Flood Risk Assessment and Drainage Strategy

Proposed Development at
Hither Green Lane, Redditch, B98 9BN

Document Type: Flood Risk Assessment and Drainage Strategy

Appendix 10 – NWWM (LLFA) response

Appendix 1 – Travis Baker Drawing 21169 – 1, 2 and 3 Preliminary Drainage Strategy and Finished Floor Levels

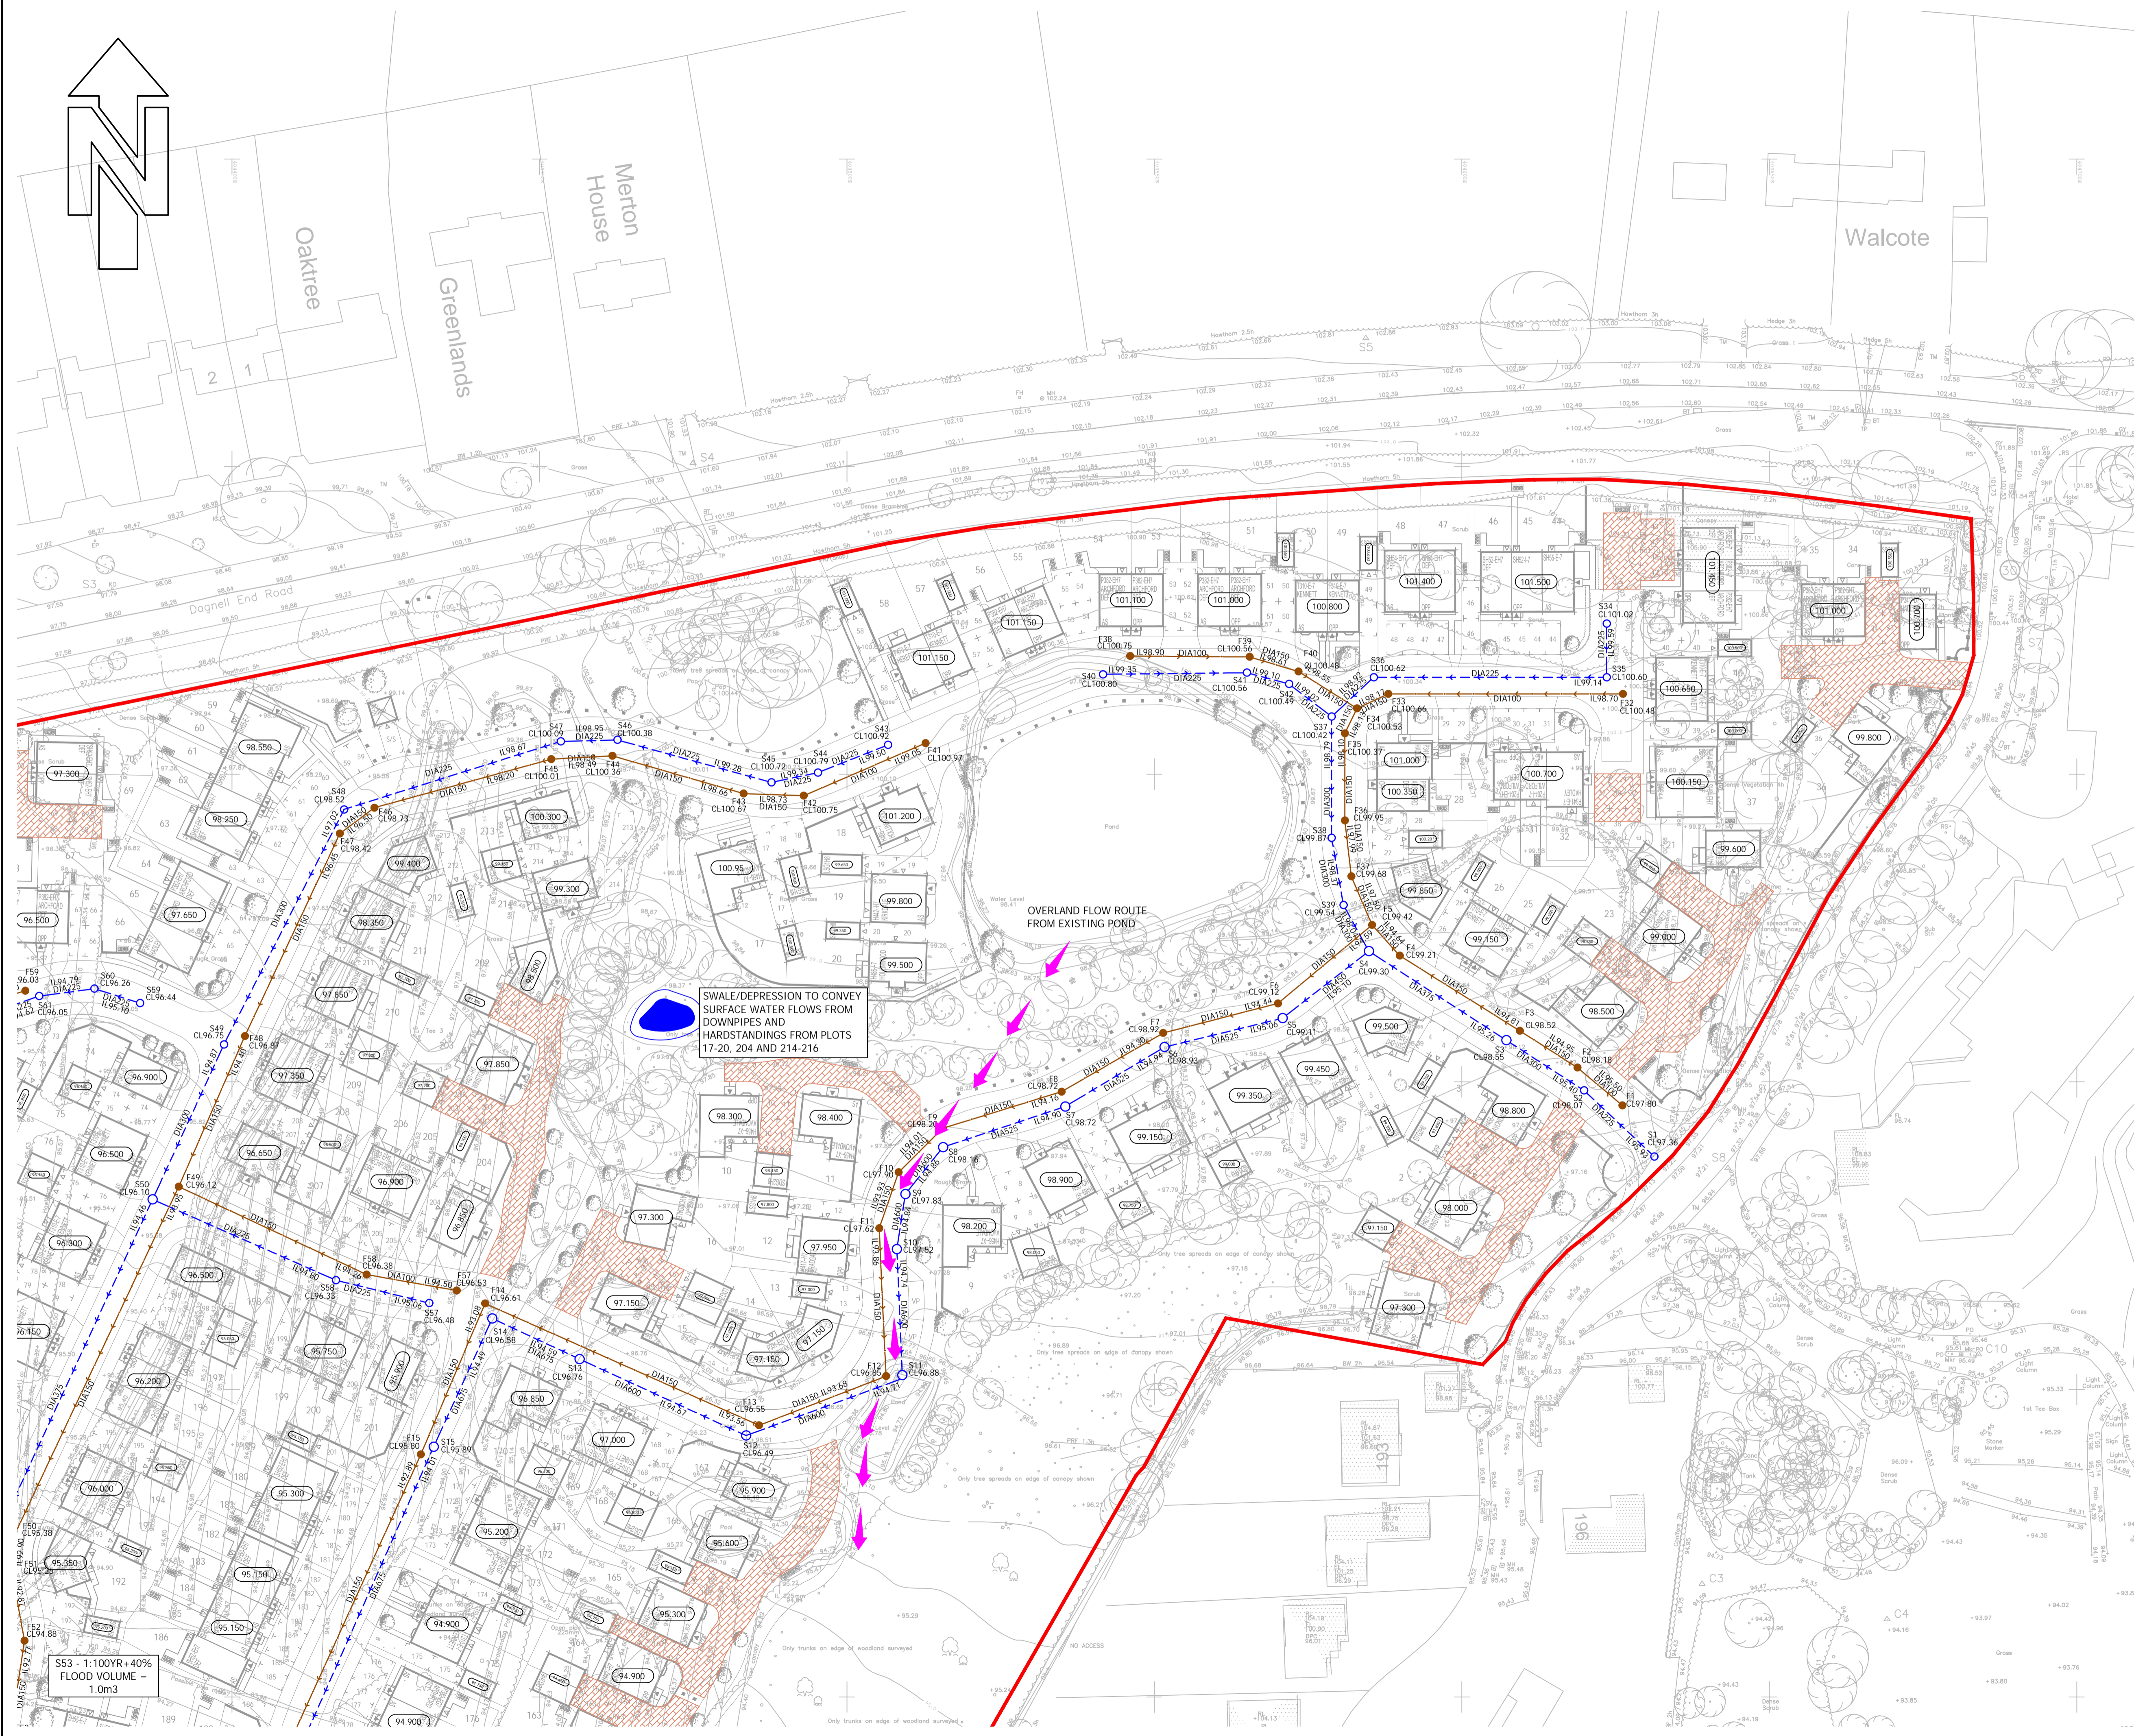
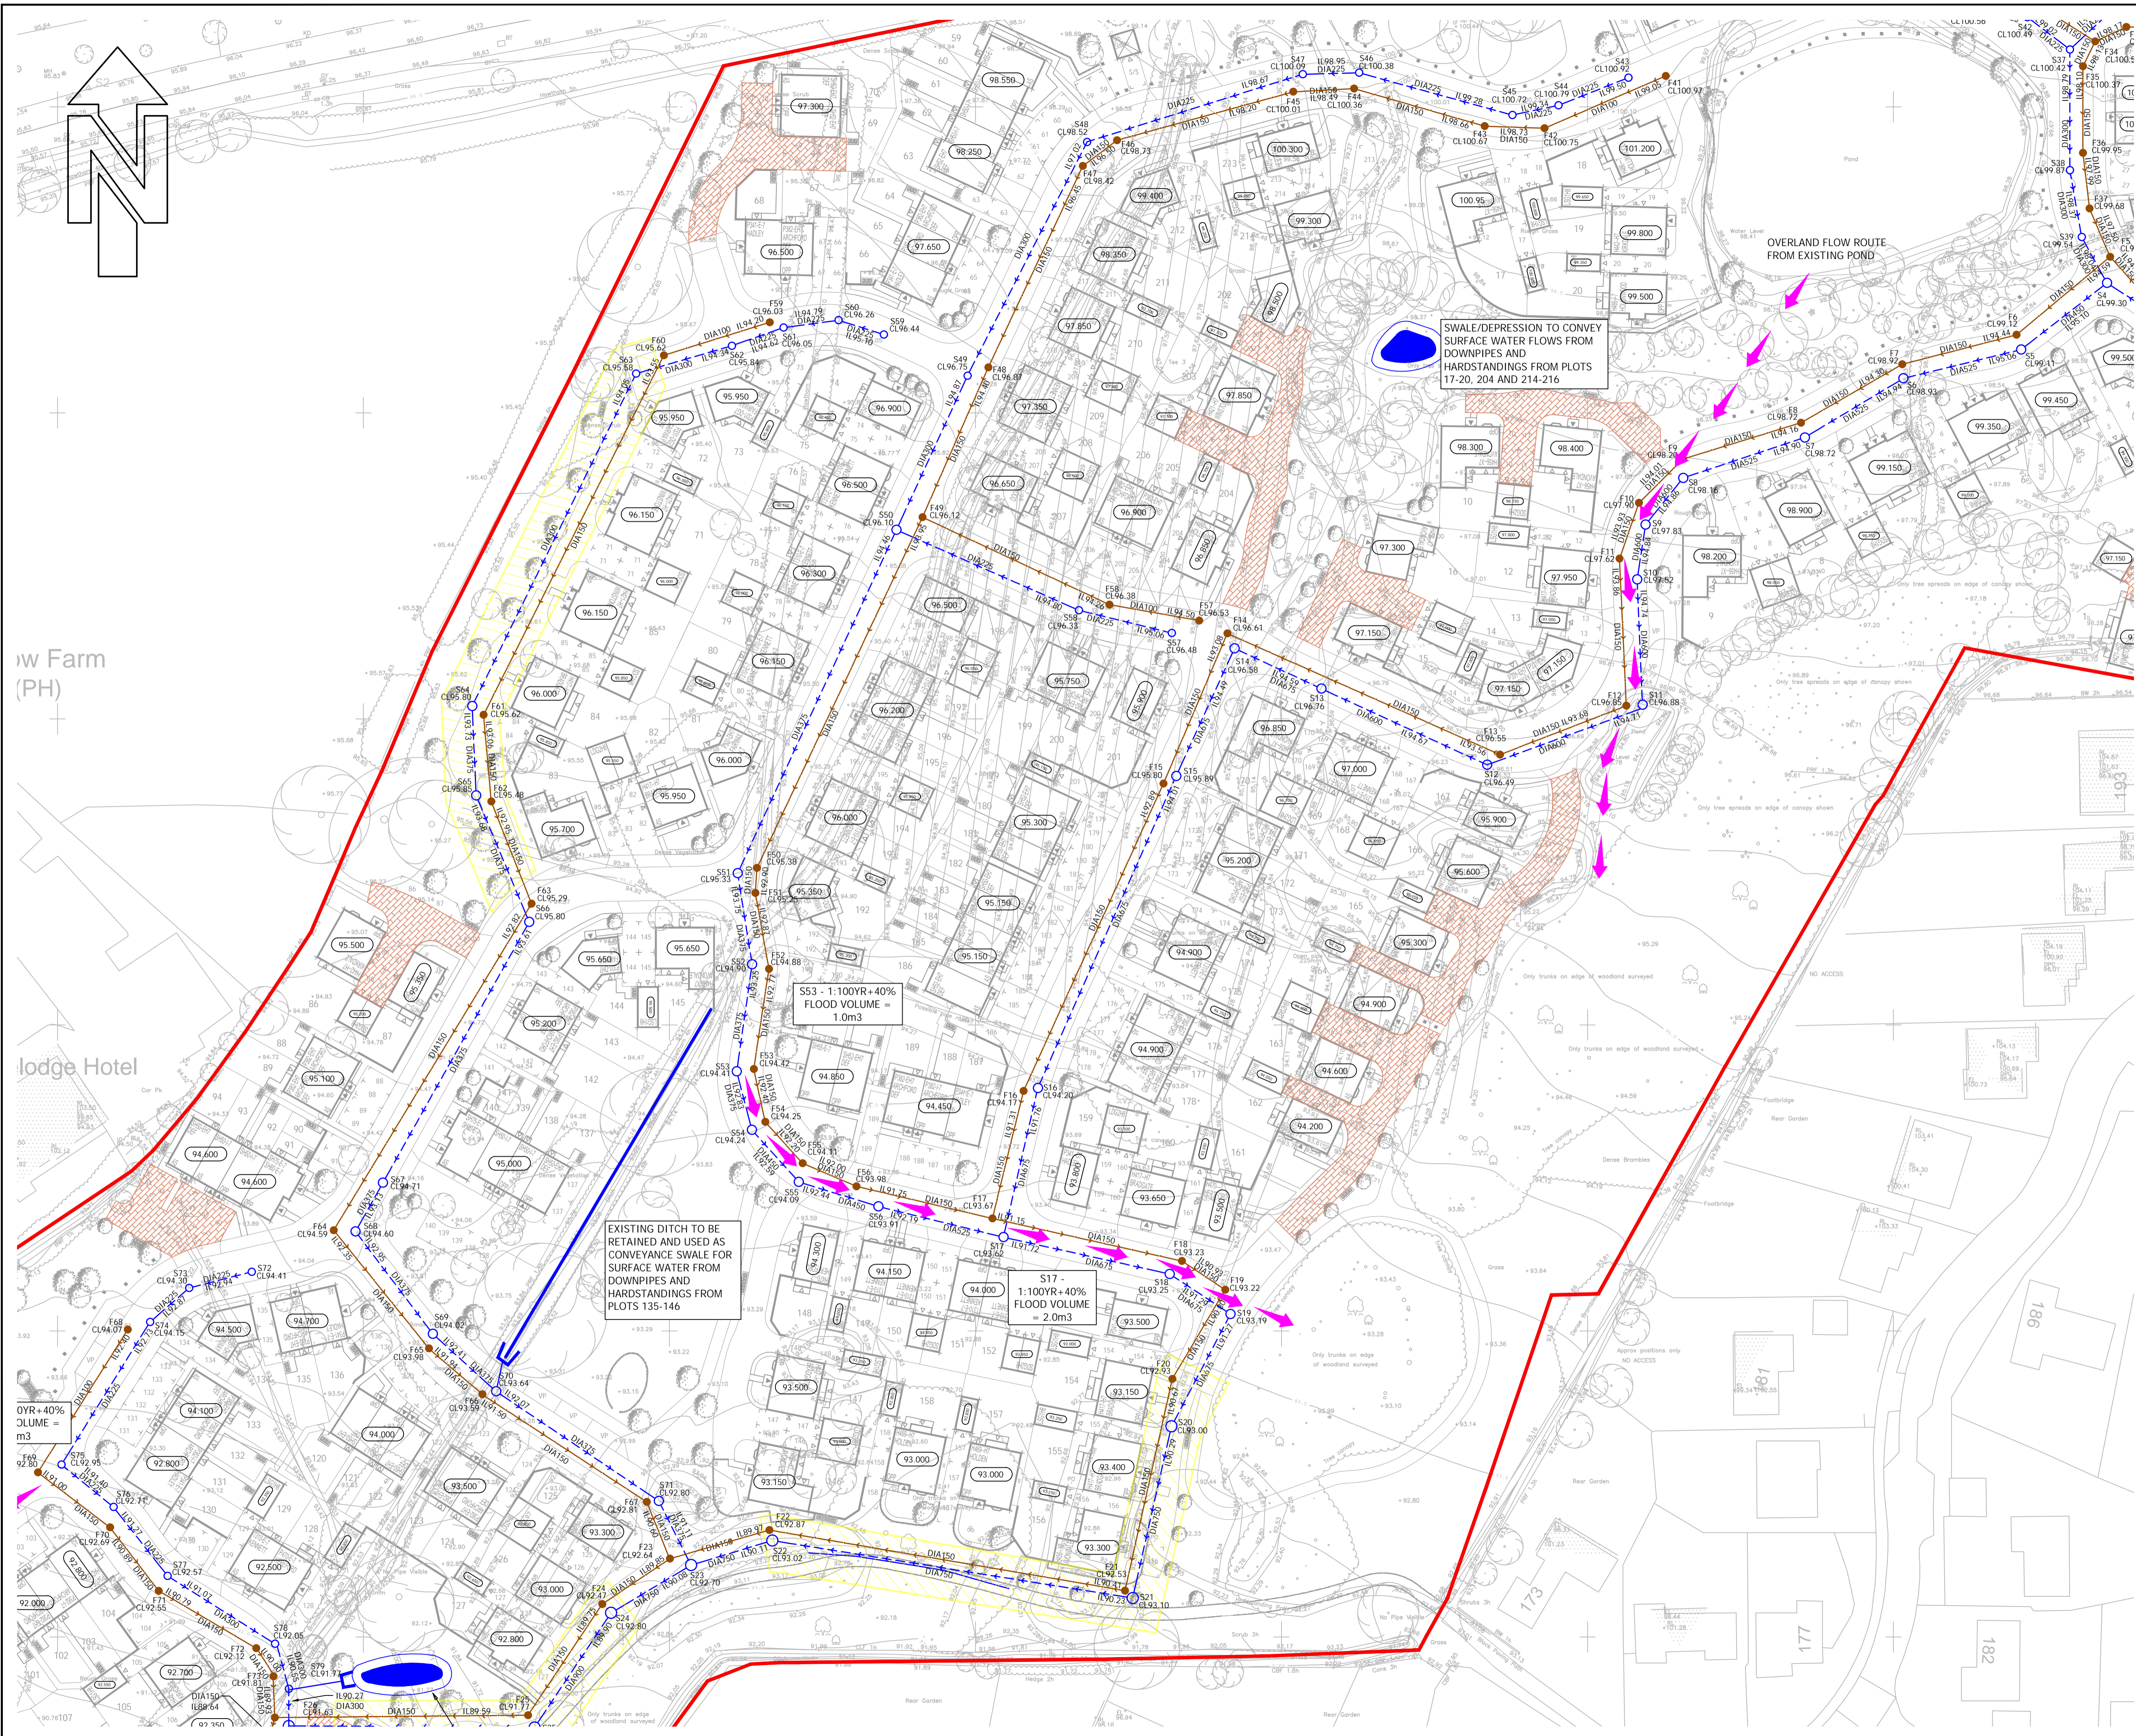
While NWWM is broadly supportive of the principle of development on this site, based on the current proposal for the site there are a several elements that are contrary to policies 17&18 of the Redditch Local Plan. We would raise a **Holding Objection** to this application until the proposed drainage layout is revised and it addresses concerns raised in the following comments.

Within the FRA an outline drainage strategy has been proposed, the proposed level of retention is acceptable (up to 1 in 100 year AEP + 40% for climate change) and the proposed off site discharge rate is acceptable. However, beyond surface water attenuation the proposed drainage scheme provides minimal further benefits. Calculations for the scheme have been provided, however they have not been assessed as they will need to be revised to accommodate revisions to the drainage layout if the scheme to be acceptable to the LLFA.

The use of a single retention feature which is located on the periphery of the development will limit benefits with respect to water quality and amenity. It does include permanent water, which is positive however this it uniformly deep, natural ponds provide a mixture of depth profiles. There are no source control SuDS features provided by the scheme. Features such as permeable paving or drained tree pits should be incorporated into the design.

The site should be split into its natural catchment areas and a series of smaller retention features should be proposed. With the appropriate inclusion of source control features this should ensure there is still suitable attenuation volume provided by the scheme. These features should be incorporated into open space areas so that they provide amenity value. Pedestrian routes can be provided adjacent swales to provide green corridors through the development.

One thing that I did notice hadn't changed the re-route of the pavement with regards to Tom's previous comment...

Can you also confirm if you have incorporated Tom’s comment about permeable paving?...

“With respect to the proposed permeable paving the attached detail is one we have specified on another site recently. The last detail would be how we would want the adjacent properties to have their downpipes connected to the paving, then there would need to be an under drained sump which then connects to the adopted sewer.”

Sorry for being so slow to come back to you on this. I have been trying to speak to the planning officer at Redditch this week but he has been on leave all week and isn't back till Monday. I have reviewed the revised details you sent over. I think given the limitations of severn trent allowing land drainage to their network and the issues of the invasive species we will have to accept the larger pond not being connected to the network. The additional features you have added are welcome, however can you clarify, is the intention that the surface water ,i.e. downpipes from properties will discharge to these features before draining to the sewer network? If so can you just indicate this clearly on the drawing.

With respect to the proposed permeable paving the attached detail is one we have specified an another site recently. The last detail would be how we would want the adjacent properties to have their downpipes connected to the paving, then there would need to be an under drained sump which then connects to the adopted sewer.

I have reviewed the revised drainage strategy and can see that you have rerouted the pavement. Secondly, if you are confirming that you have incorporated the second point from my previous email, I can confirm that I am happy with the latest drainage strategy.

I attach the revised drainage strategy drawings for your approval. Firstly I can confirm that the items below were already incorporated into the scheme. Secondly, following comments from the tree officer we have reduced the number of plots (around plots 136-140) that does not affect the drainage strategy and have moved the inlet and outlets of the southern pond to reduce the effect on surrounding trees. Again this doesn't impact on the drainage strategy itself.

Please find attached revised drainage strategy drawings incorporating the additional features that you requested. I trust they meet with your approval but should you require any further information please do not hesitate to contact me.
